STAFF RECOMMENDATION

1406 Eastland Avenue

March 17, 2021

Application: Partial Demolition; New Construction—Addition and Detached Accessory Dwelling Unit; Setback Determination;
District: Lockeland Springs-East End Neighborhood Conservation Zoning Overlay
Council District: 06
Base Zoning: R6
Map and Parcel Number: 08305038500
Applicant: Lauren Perkins
Project Lead: Melissa Baldock melissa.baldock@nashville.gov

Garage/Apartment Plan
 Scale: 1/4" = 1'-0"
1406 Eastland Ave
Nashville, Tennessee

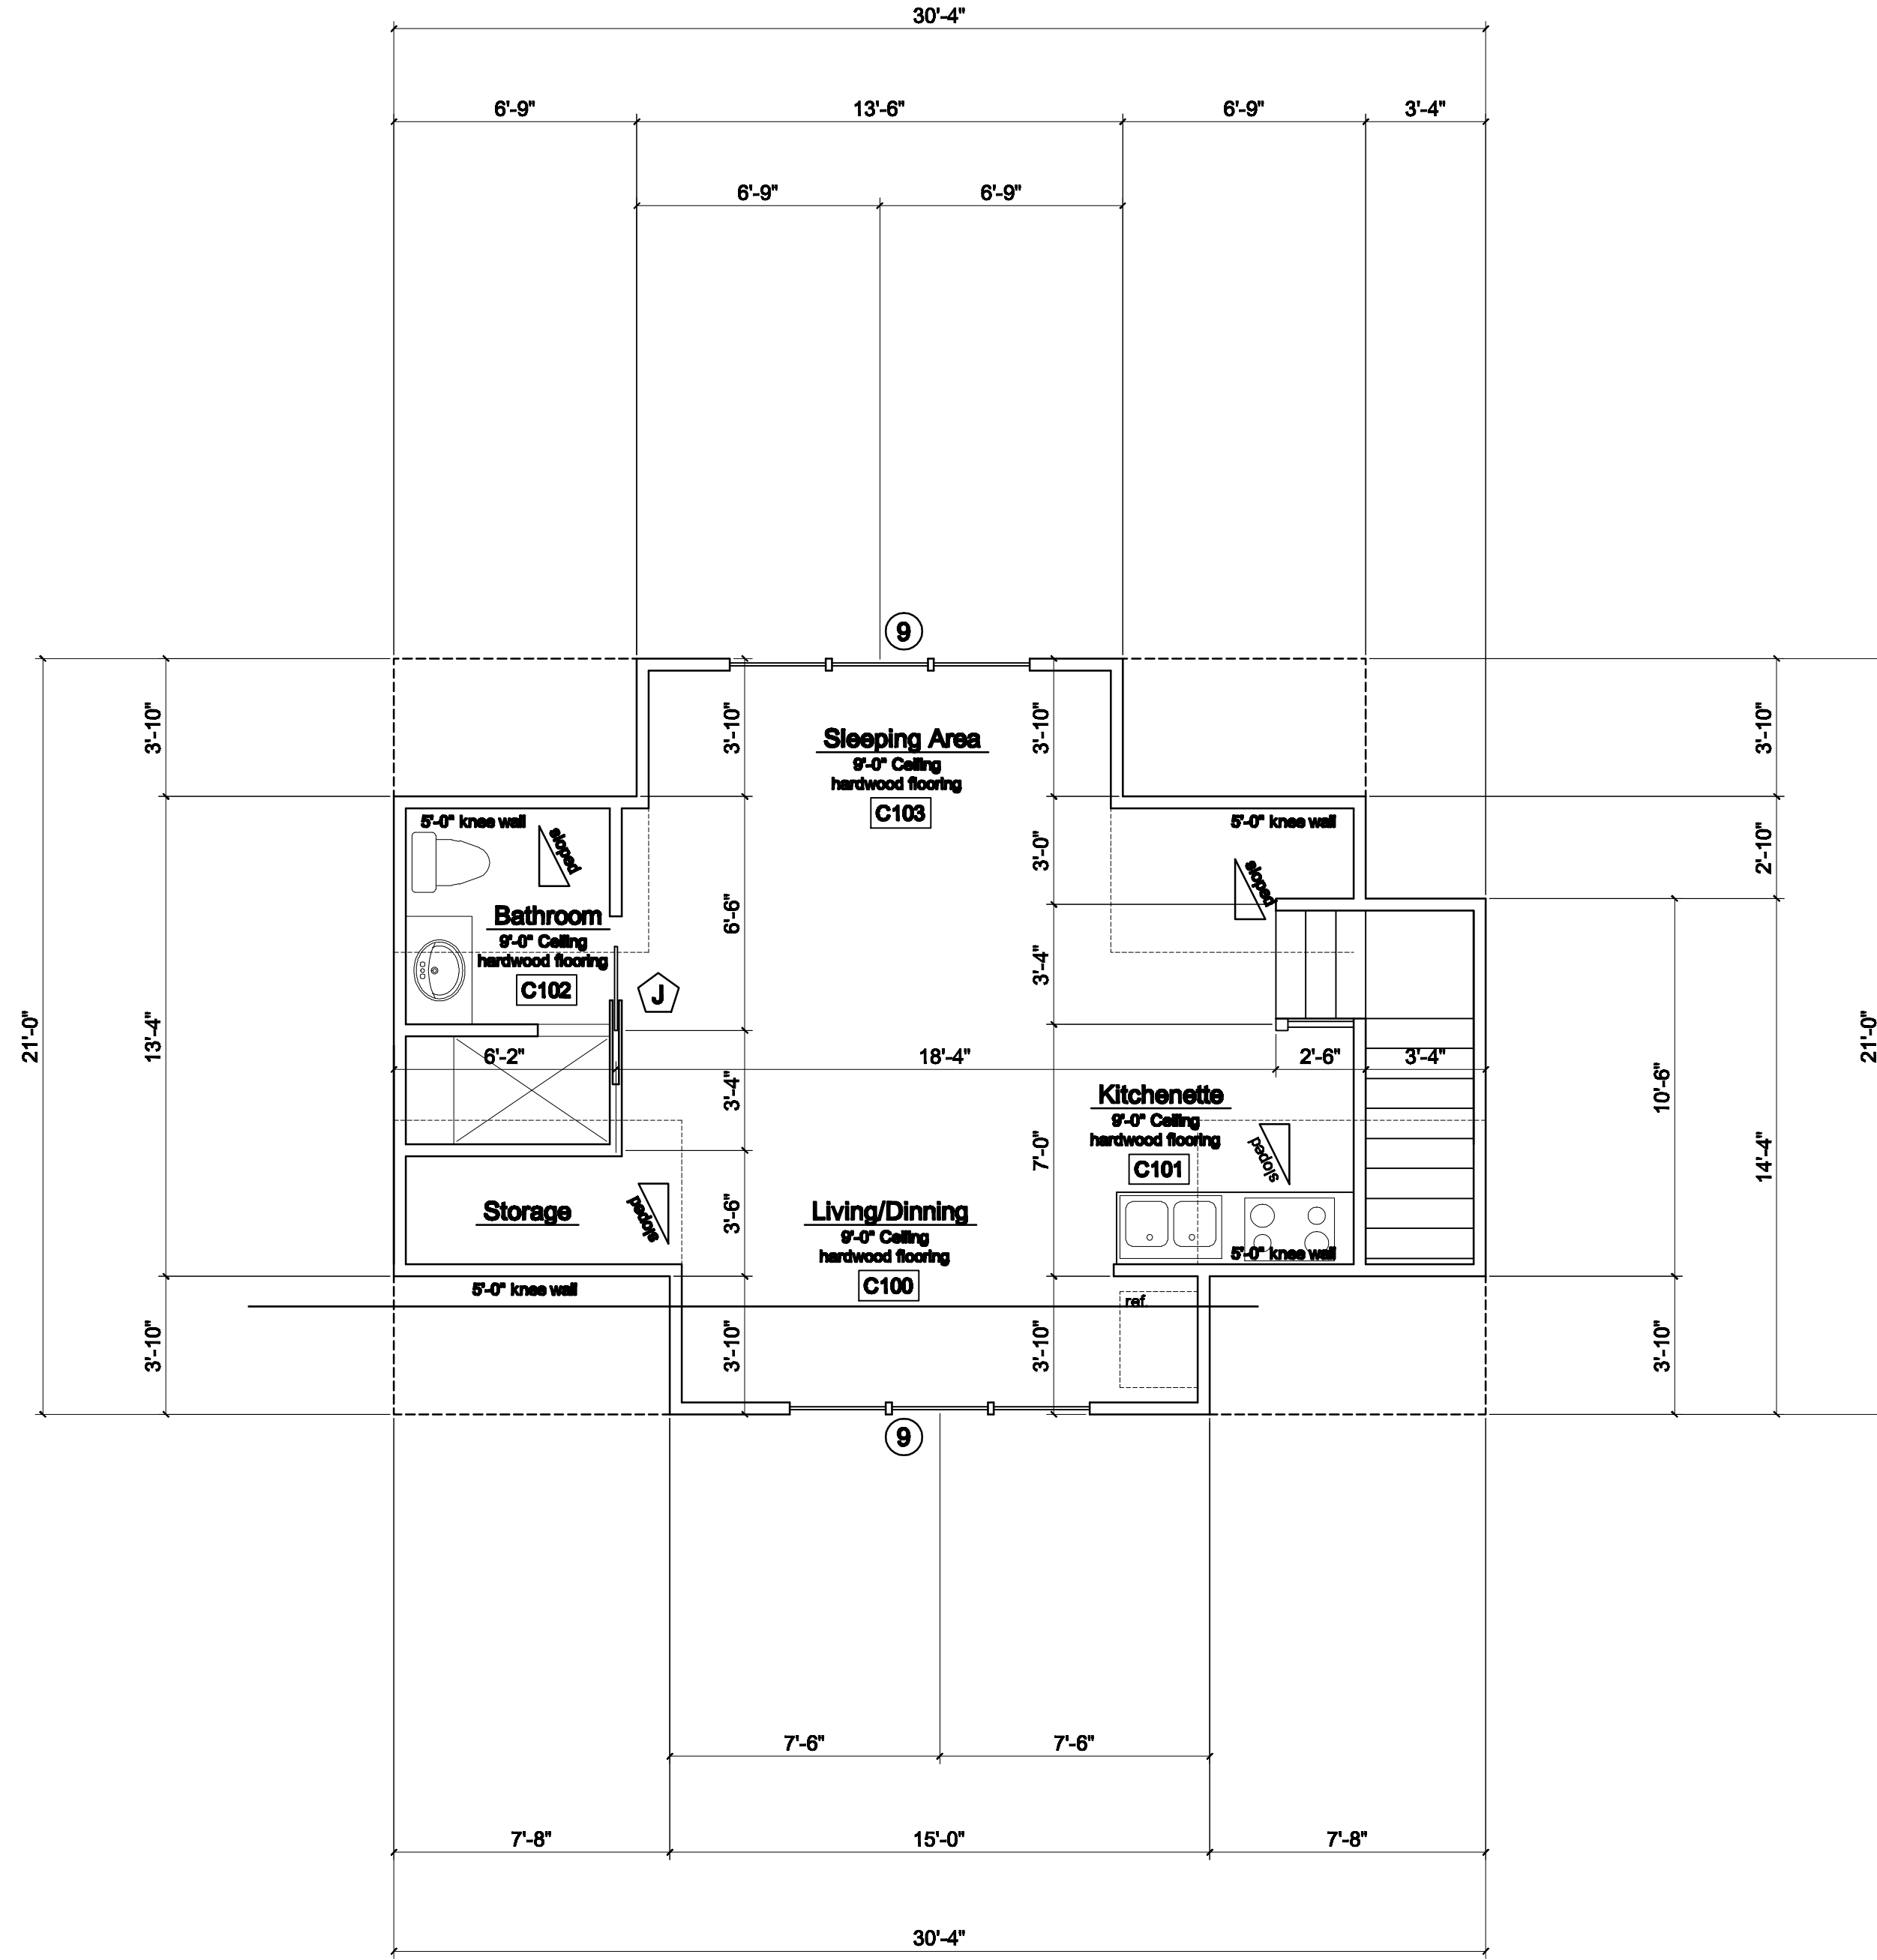
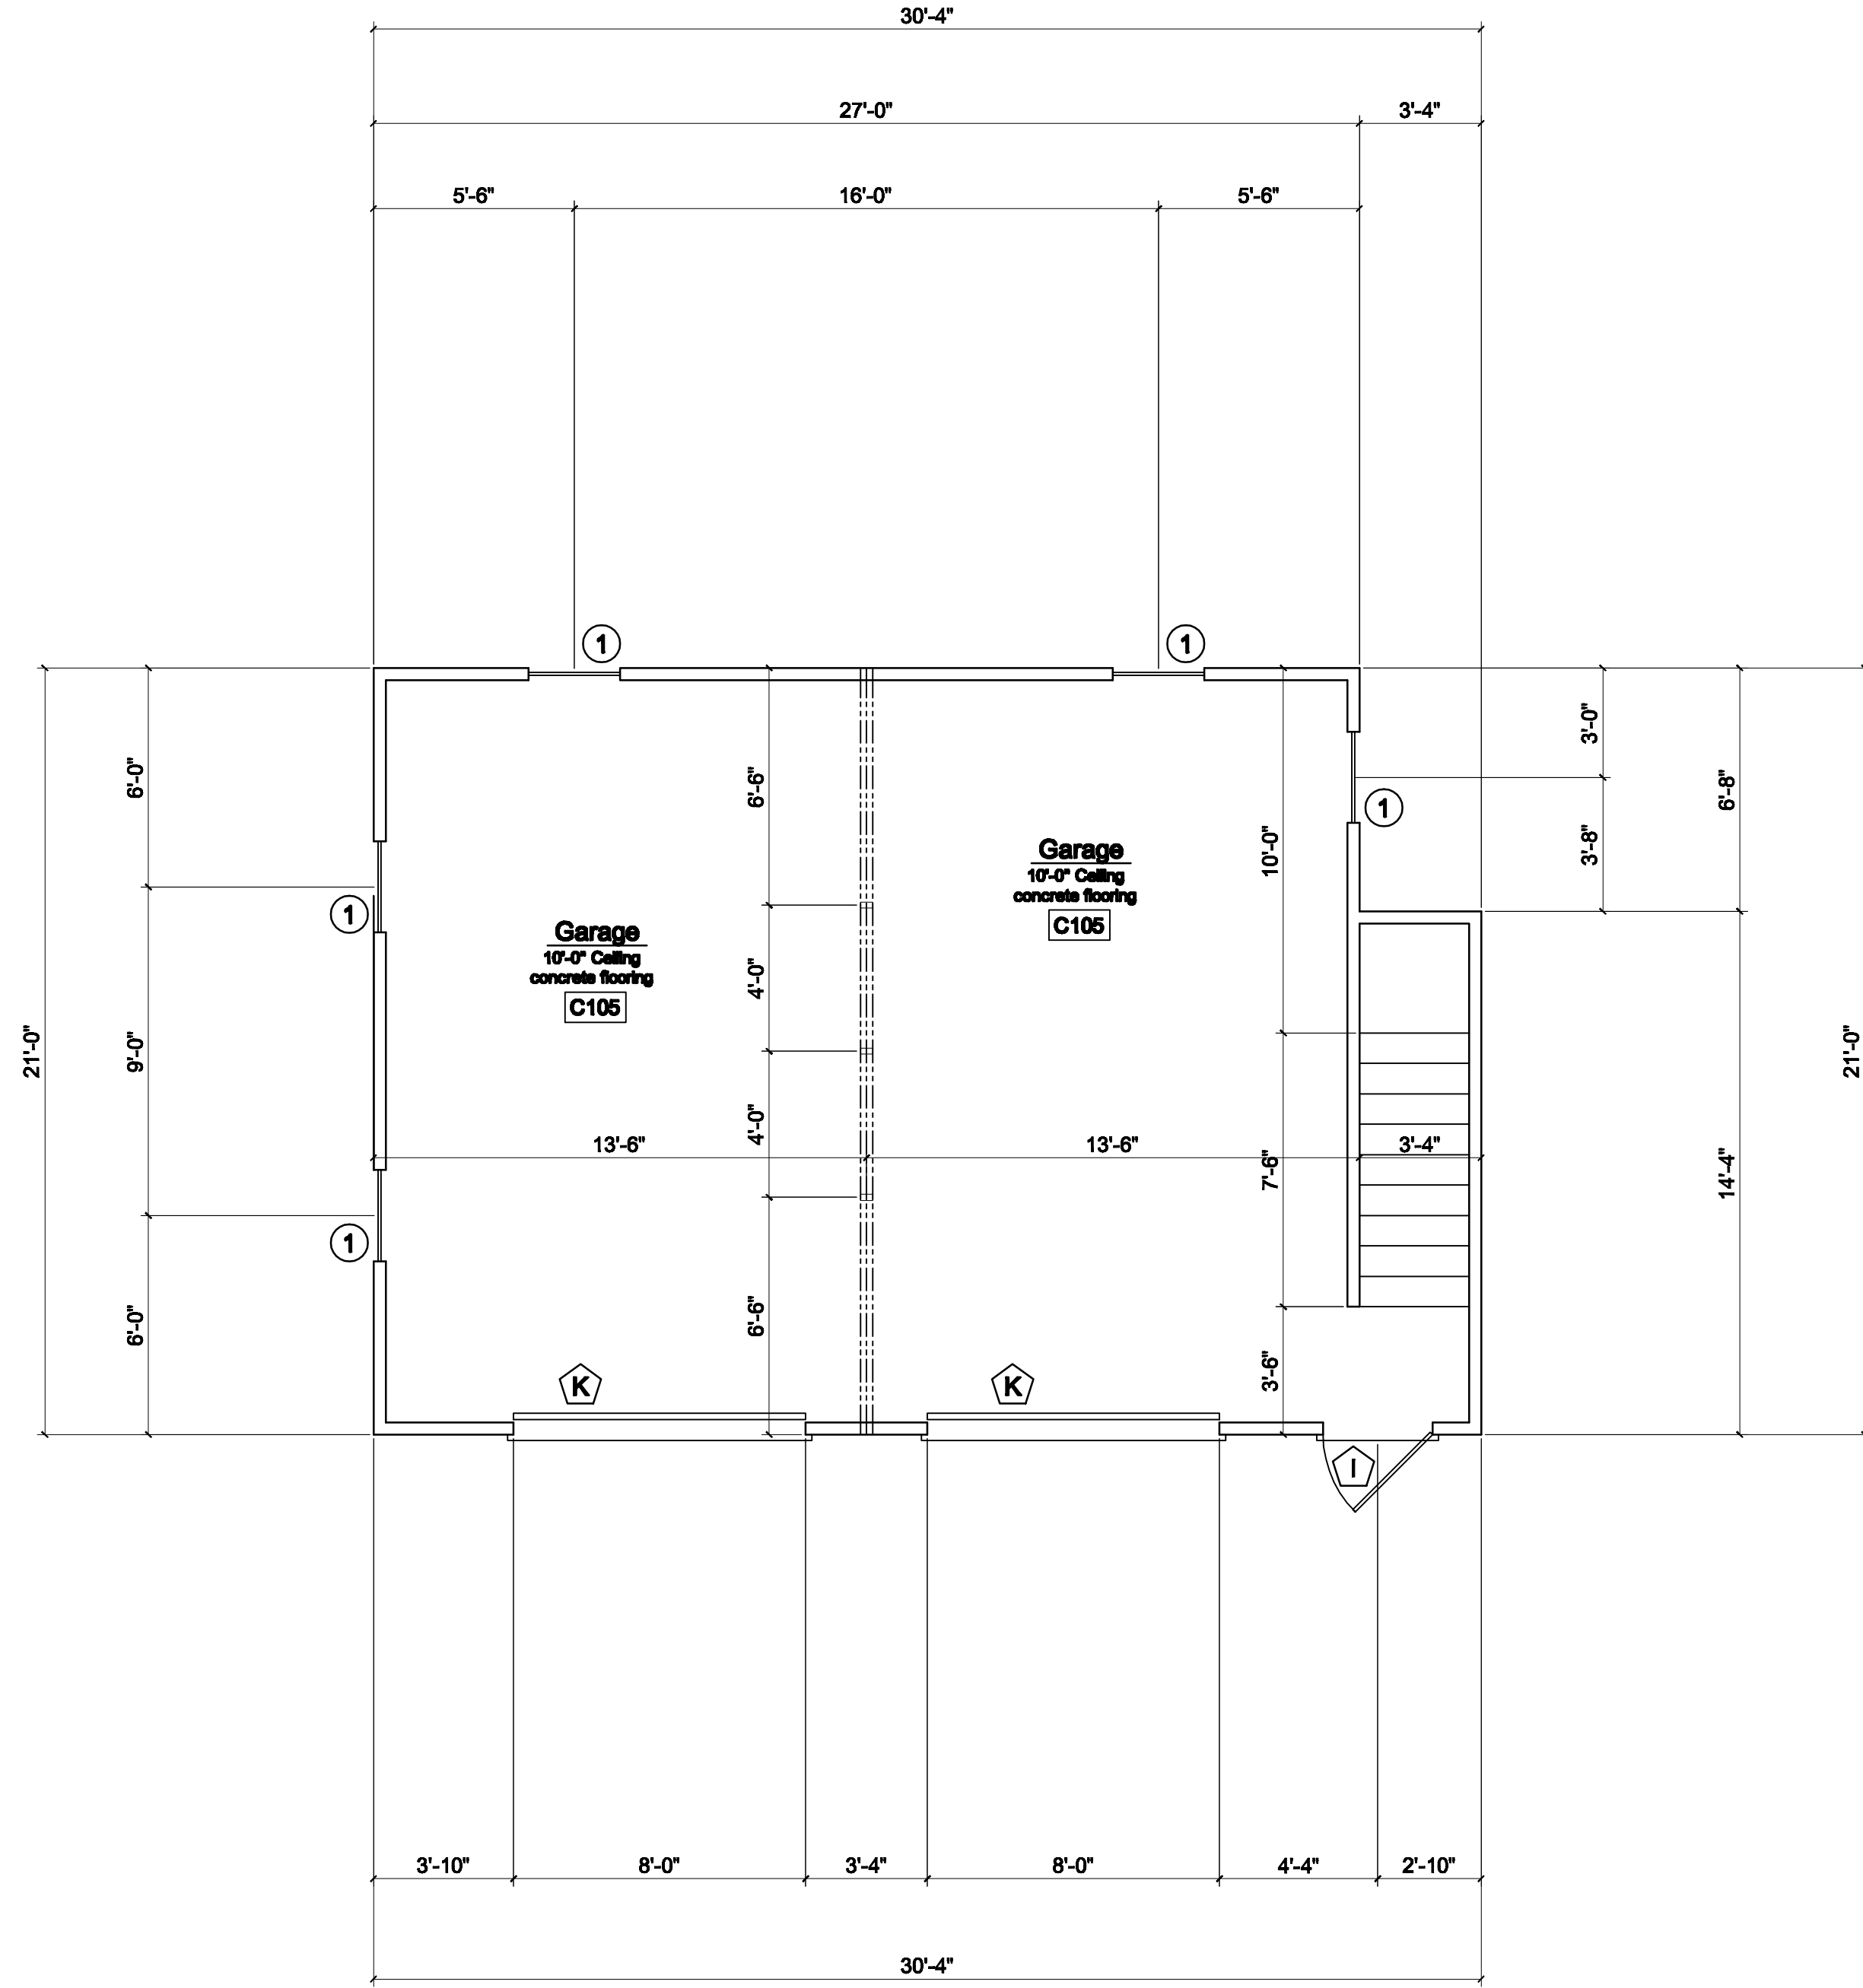
With the condition that the dormers be inset two feet (2') from the wall below, staff finds that the propose DADU's height, scale, placement, setbacks, materials, roof form, and overall design meet Section II.B.8 of the design guidelines and 17.16.030. G., the DADU Ordinance.

1. The dormers on the DADU be inset two feet (2') from the wall below;
2. Staff approve the roof shingle color and all windows and doors prior to purchase and installation; and
3. Staff approve the location of the HVAC unit and all utilities.
